This software updates or alters the functions and features noted below. The instructions and information that follow are meant as a supplement to the original instruction manual that accompanied the T32MZ transmitter. Please refer to the original instruction manual where applicable, but replace the steps indicated below with these instructions. Please note that the software update will be finalized the first time that the T32MZ is powered up, after the software has been applied. As such, it may require a few moments before the Start screen appears. Please check to ensure that the update has been installed.

1. Add Stick mode

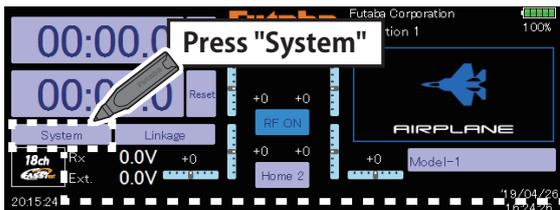
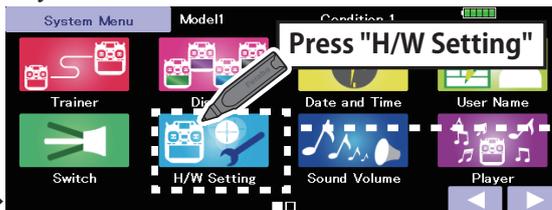
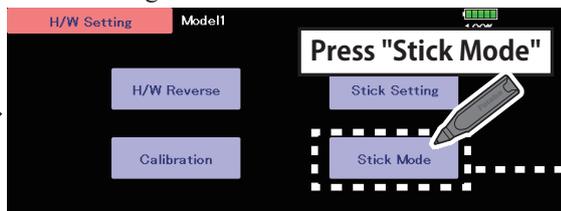
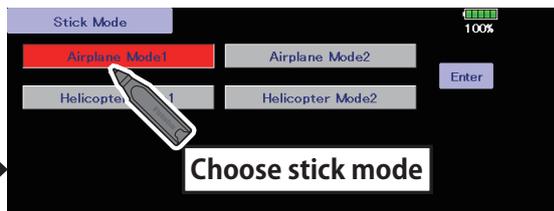
A stick mode setting screen has been added.

When changing the stick mode, select one of the following stick modes after adjusting the spring / ratchet of the left and right sticks.

If you want to change the stick mode, change the spring / ratchet according to **page 20 of the manual** and make the following input.

If you want to change the stick mode, change it immediately after purchase (before data entry).

*After changing the stick mode, the model type will be AIRPLANE 1-AIL or HELICOPTER H-1. Change the model type to after changing the stick mode.
